**DEFENSE NUCLEAR FACILITIES
SAFETY BOARD**

The Defense Nuclear Facilities Safety Board (Board) completed a review of a revised preliminary documented safety analysis for the High-Level Waste Facility at the Waste Treatment and Immobilization Plant project located at the Hanford Site. The review was limited to the hydrogen control strategy, as well as fire protection and chemical safety programs.

Staff Report

Review of the Preliminary Documented Safety Analysis for the High-Level Waste Facility

Figure 2. A plot of the LFL of hydrogen as a function of temperature (derived from [17]).

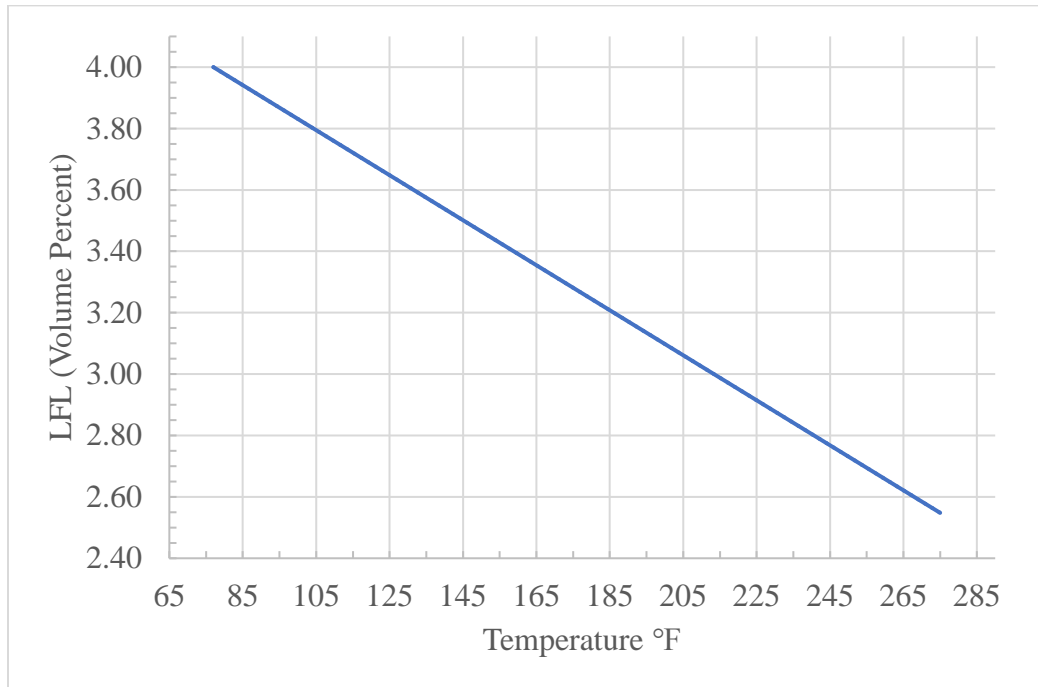
Observation 4: Temperature Effects Are Not Fully Considered in the Volcanic Ashfall Safety Strategy—As discussed, the control strategy for a volcanic ashfall event includes a passive safe shutdown of the facility that secures electrical power to all systems. With ventilation and other cooling systems shut down, the facility’s temperature will increase. This temperature increase was not considered in the safety analyses of hydrogen hazards during the ashfall event.

Project documents show that facility air temperatures could reach beyond 267 °F during the passive safe shutdown. There are three impacts to safety analyses for hydrogen hazards from an increased facility temperature:

1. Hydrogen generation rate increases with rising waste temperature. The hydrogen generation rate calculation is based on waste temperature in the HFP vessels. The waste temperature calculation assumes a maximum 113 °F ambient air temperature within the C5 confinement boundary that contains the HFP vessels [16]. A higher ambient air temperature will increase the waste temperature, which in turn, will increase the hydrogen generation rate.
2. Increased facility temperature impacts flow dynamics in the HFP vessel and connected piping post-explosion. The FATE™ calculation used to determine HOP HEPA filter survivability following an HFP vessel explosion assumes a maximum temperature within the C5 confinement boundary equal to 113 °F.
3. Hydrogen’s LFL decreases with rising temperature. Figure 2 illustrates this effect.

DOE Standard 3009-94 states: “The range of accident scenarios analyzed in a DSA [documented safety analysis] should be such that a complete set of bounding conditions to define the envelope of accident conditions to which the operation could be subjected are evaluated and documented.” Project personnel plan to update the safety analyses for a volcanic ashfall event to consider the increased facility temperatures during the passive safe shutdown. They expect revised analyses to show that the facility temperatures will be lower than originally calculated.
